Brooklyn Inland Wetlands Commission
Special Meeting Agenda
Tuesday, August 8, 2023
Zoom and In-Person Meeting
Community Center
31 Tiffany Street Upper Level
6:00 p.m.

RE: **Special Permit Modification
Townsend Development Associates, LLC
SP 15-006**

Below is an itemized response to the July 5, 2023 and July 10, 2023 Review Comments received from Northeastern Connecticut Council of Governments. For clarity original comments are in normal text and CHA responses are in **Bold**.

July 5, 2023 - Engineering Site Plan & Drainage Report Review

GRADING PLAN

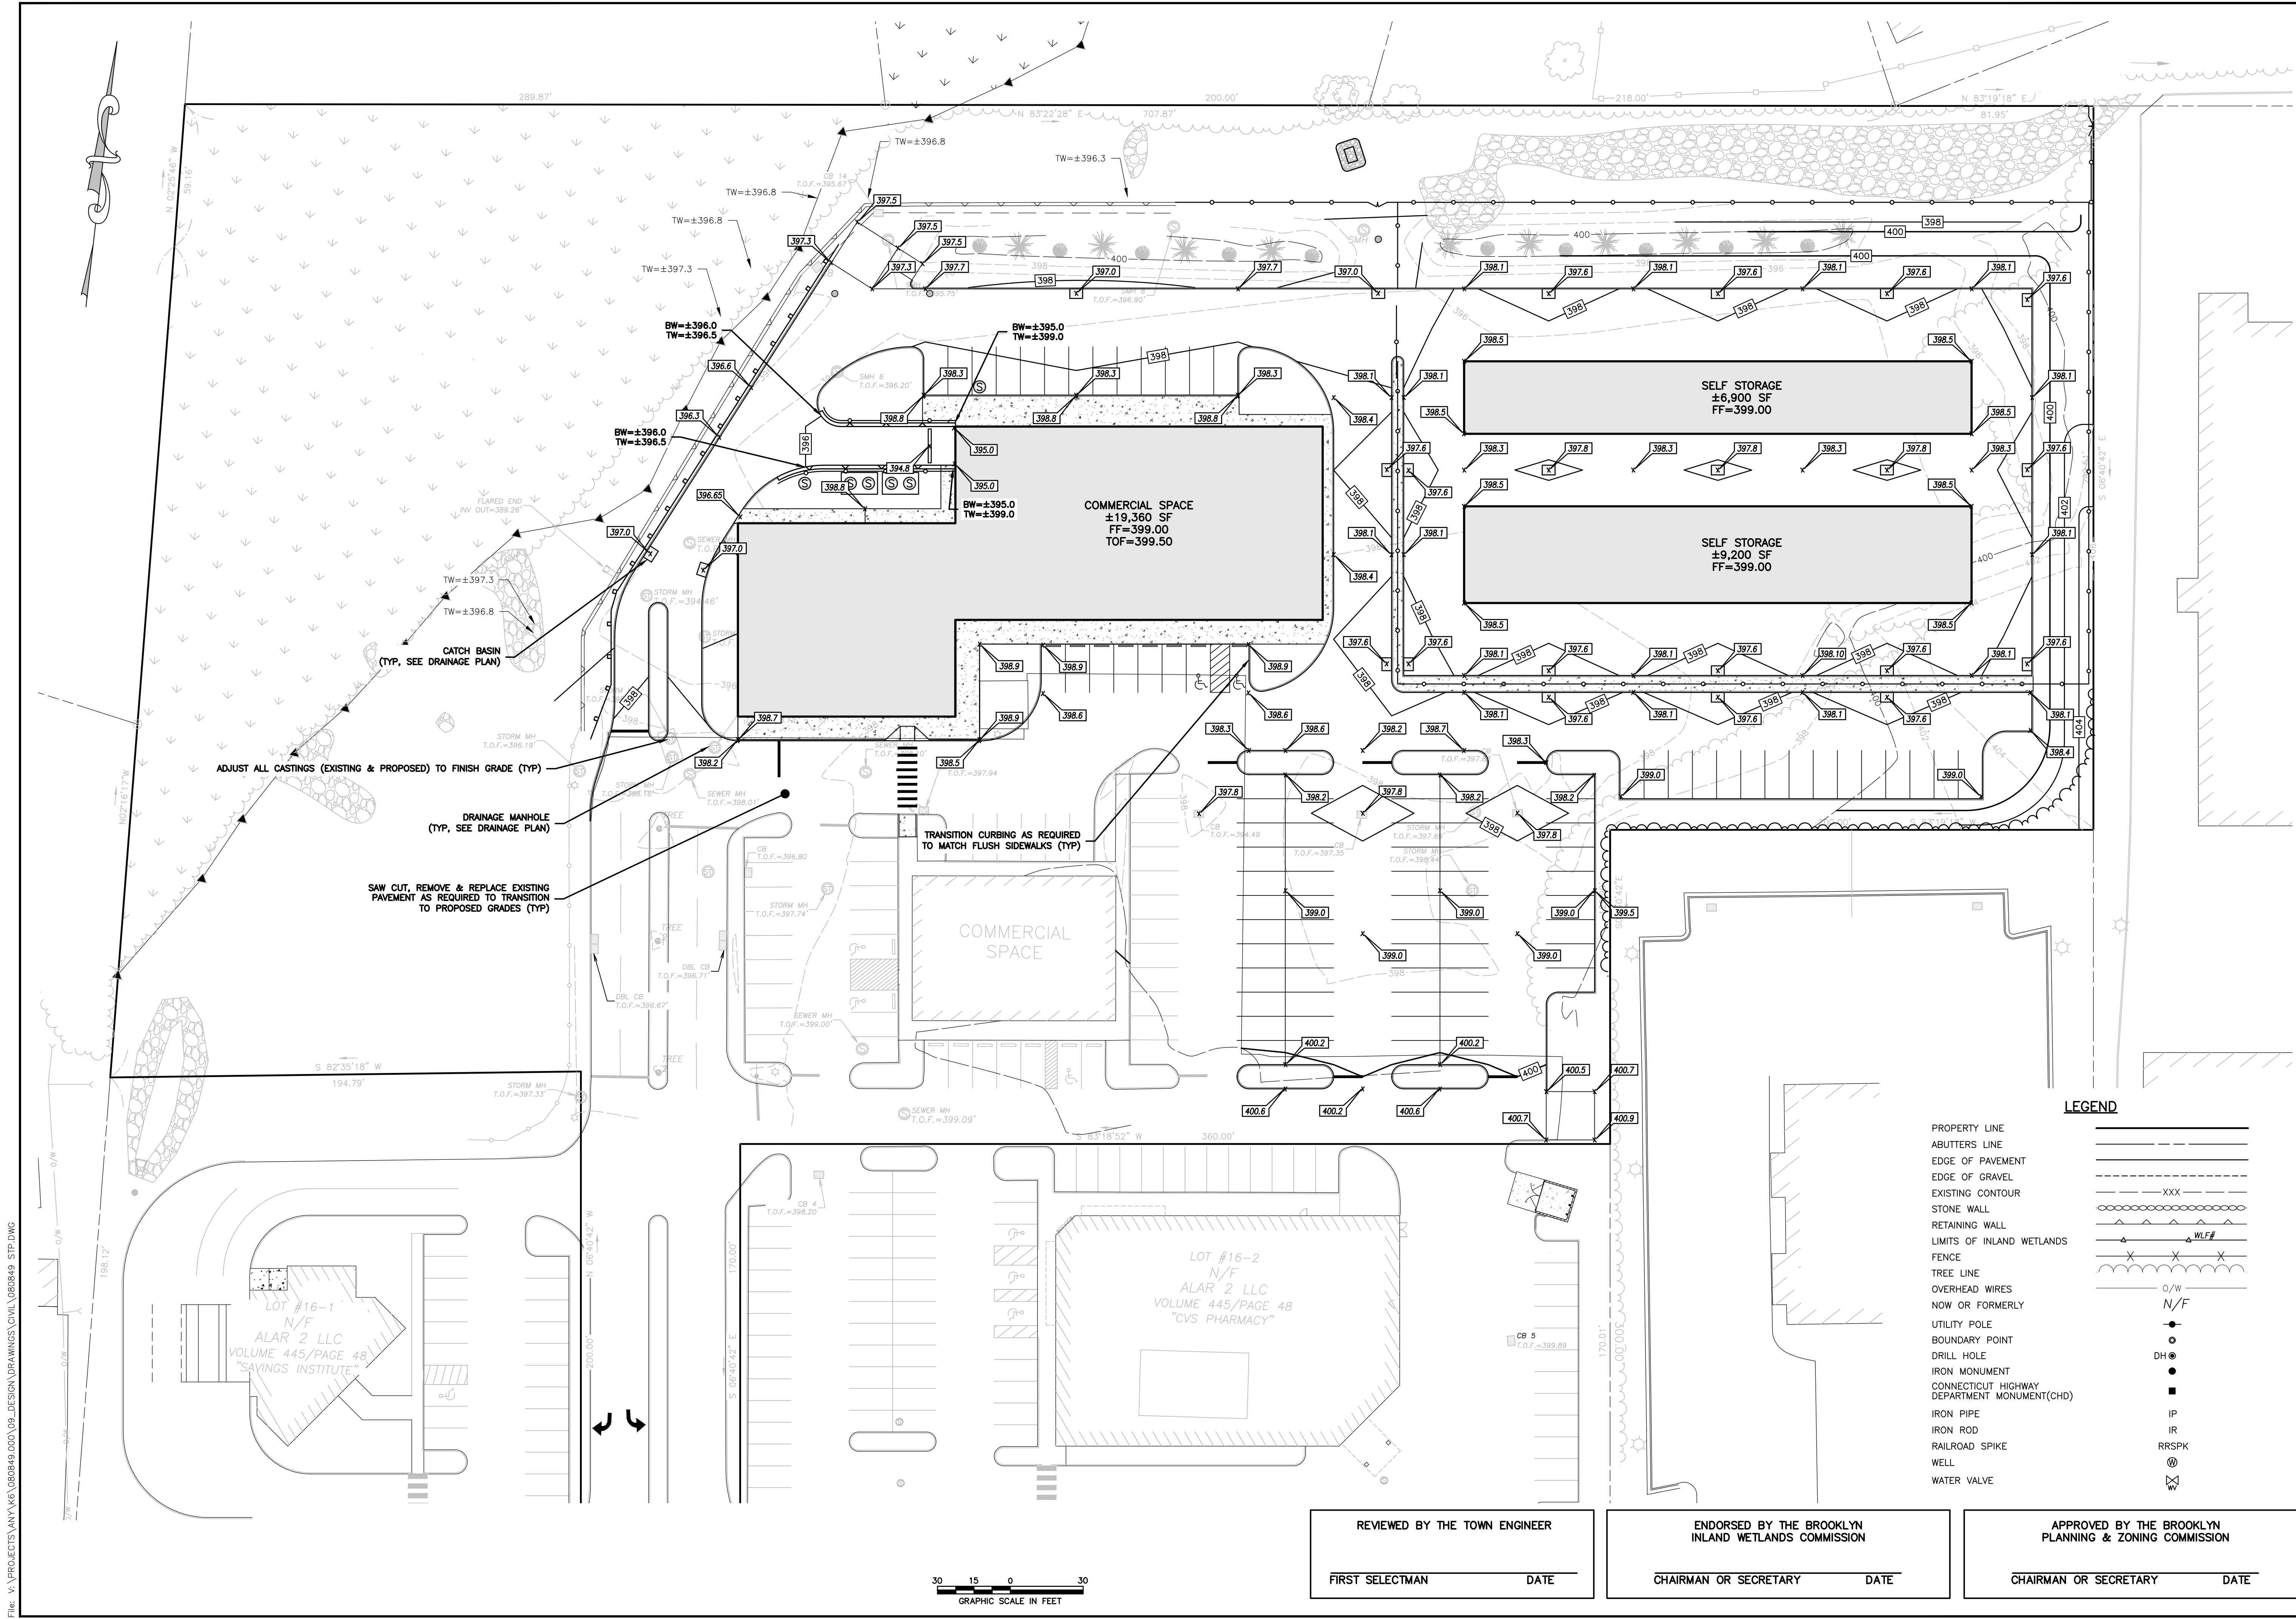
2. What does the bold line around the scour hole at the rear of the property represent? This needs to be clarified on the plan.

3. Elevations on the entire top of the existing wall at the west boundary of the property need to be included on the plan.

4. There is inadequate information identifying existing contour lines to evaluate the proposed grading. The plan must be updated to include existing elevations on all existing contour lines and resubmitted for review.

Additional contour labels have been added.

DRAINAGE PLAN

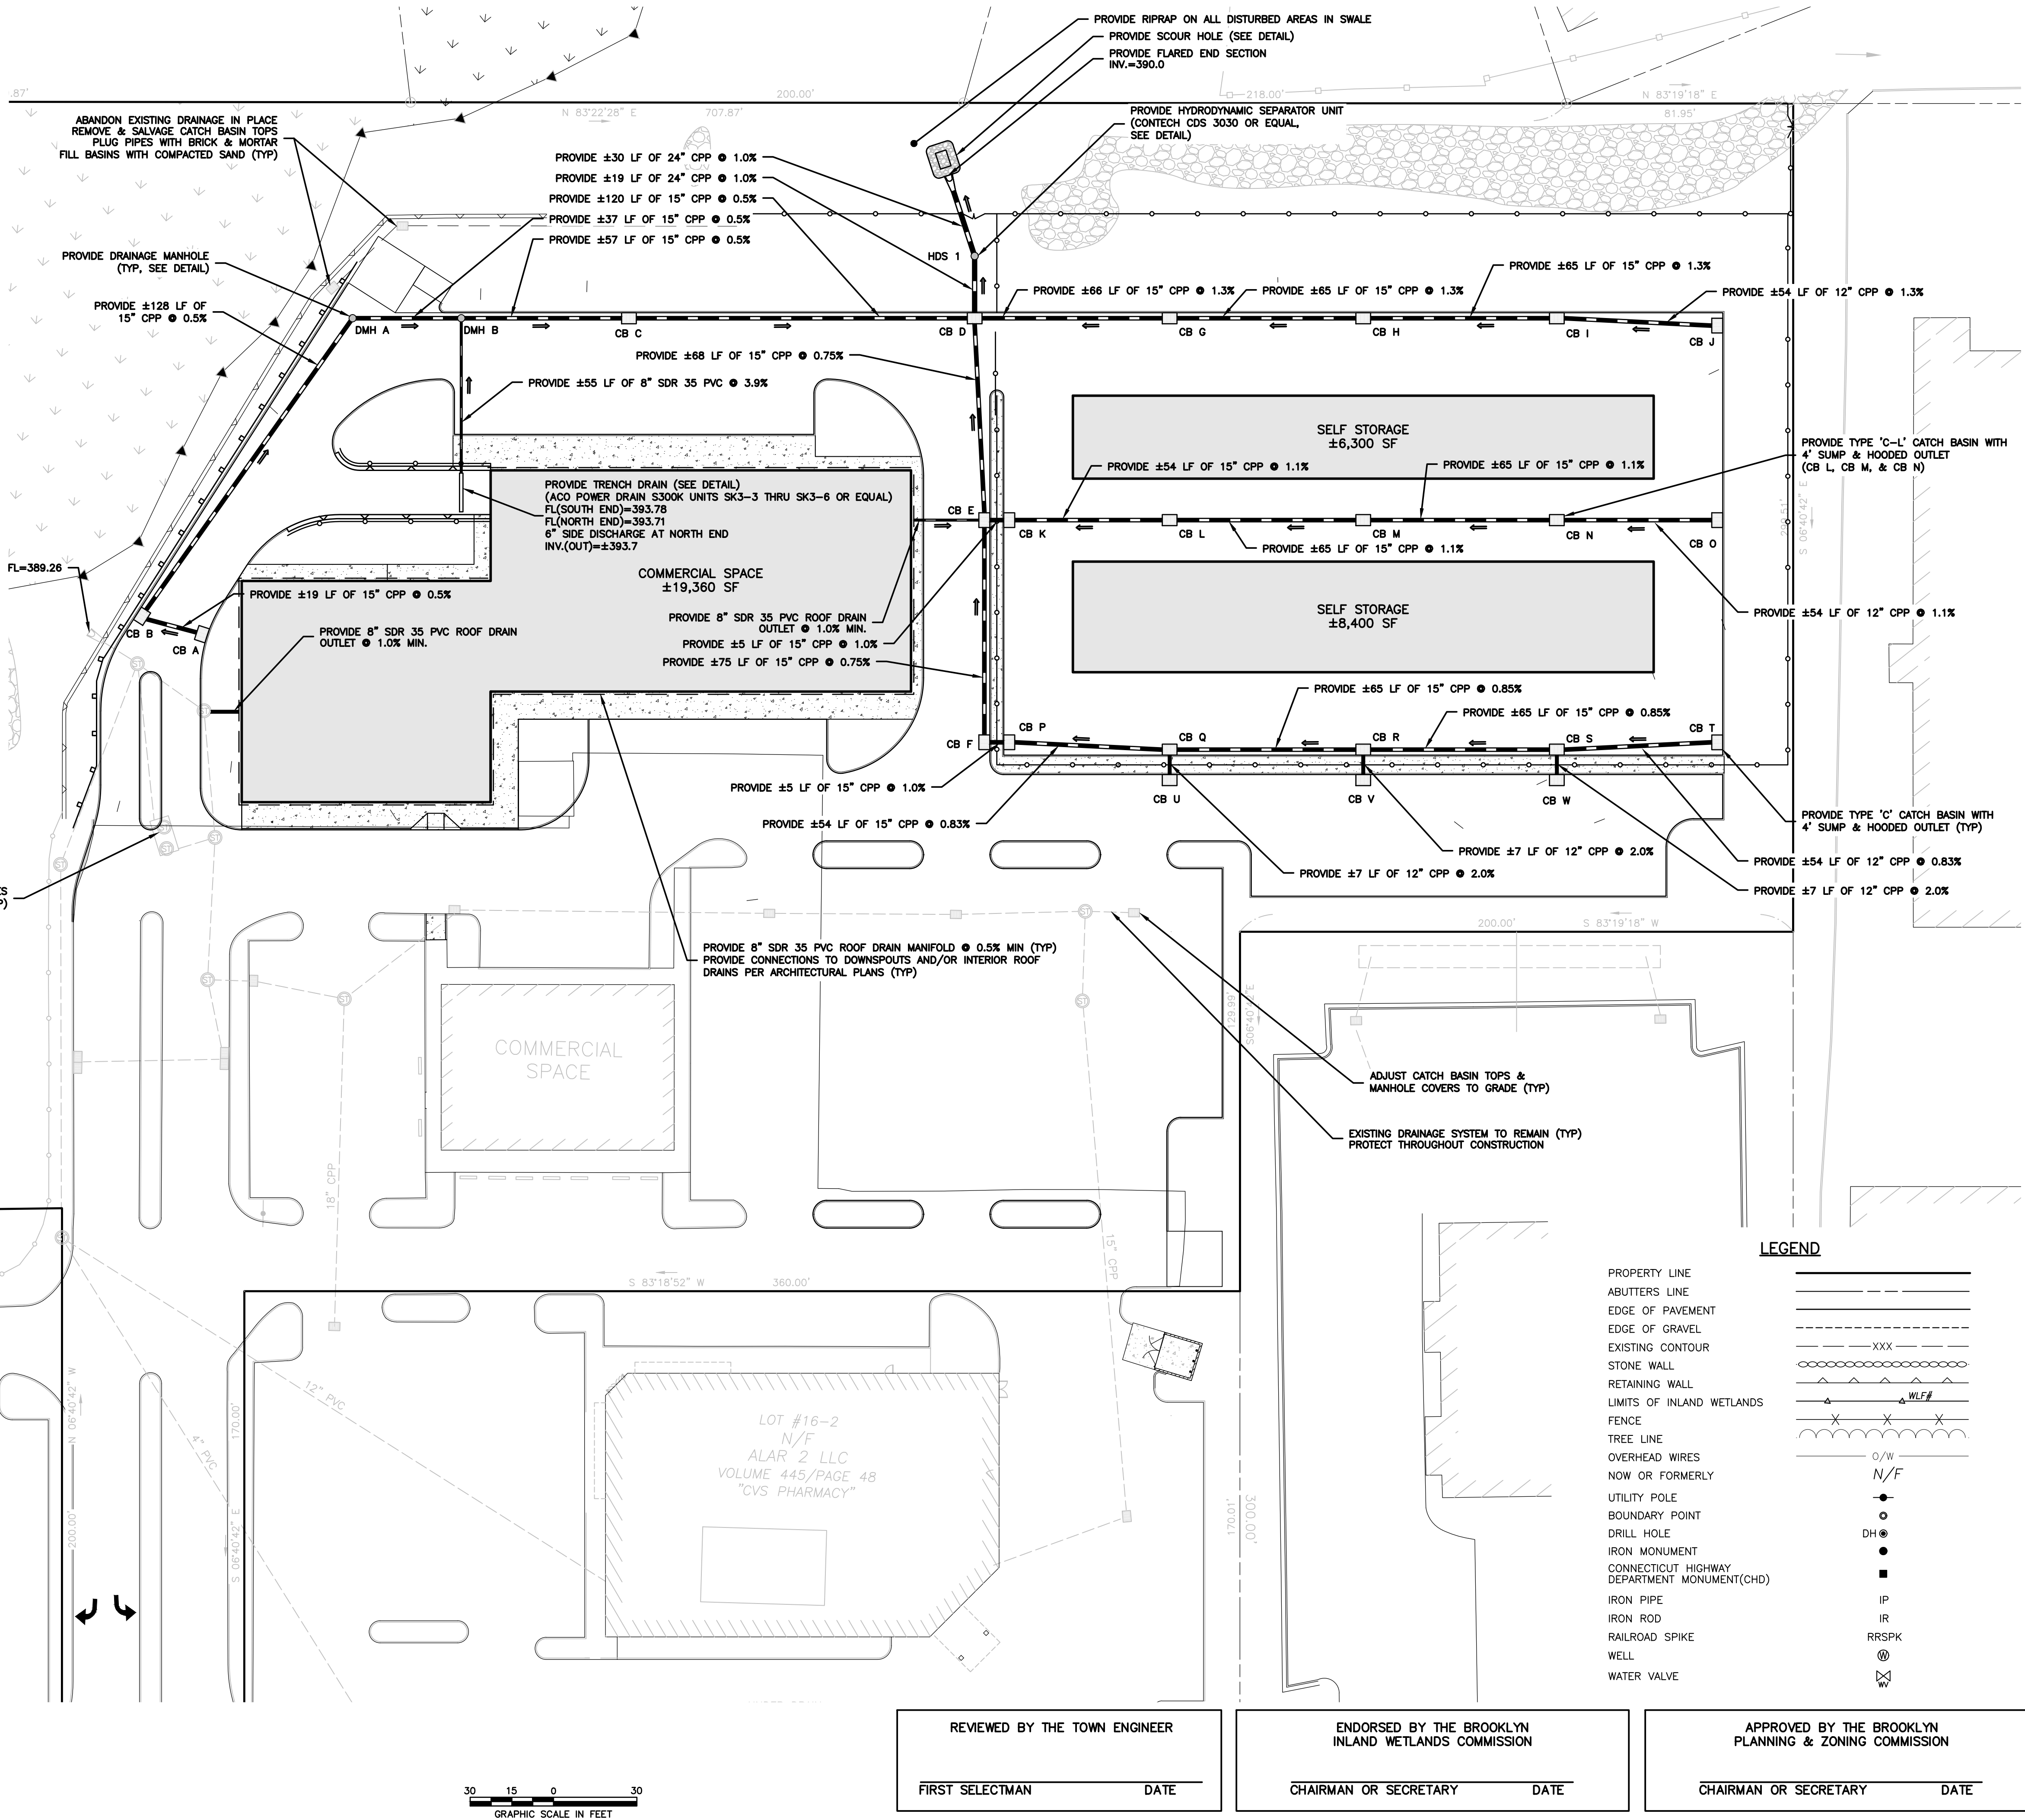
1. Direction of flow arrows need to be included on the plan.

Flow arrows have been added to the plan set.
